AXC F 2152 – CHANGE NOTES

Change notes for the AXC F 2152 controller

108427_en_22

Left-alignable INTERBUS master

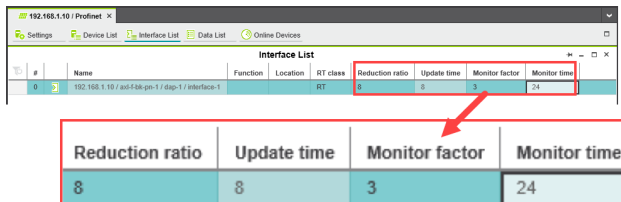
The controller now supports left-alignment of the INTERBUS AXC F XT IB master (Order No. 2403018).

Figure 2 Select Trigger task

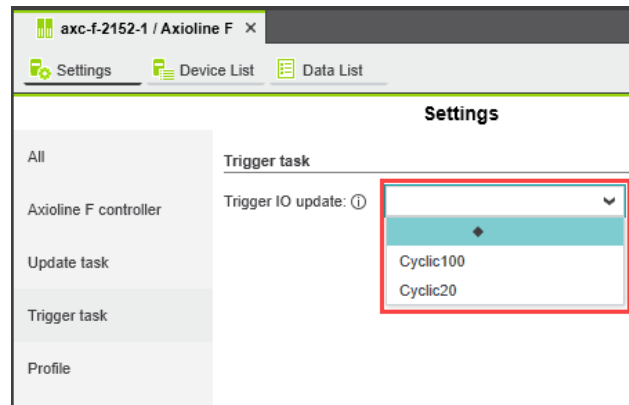
- Select the “Trigger task” view in the “Settings” editor.
- In the drop-down list, select the task that is to trigger the Axioline F I/O data update.

If you do not select a task, the update will occur by default every 50 ms.
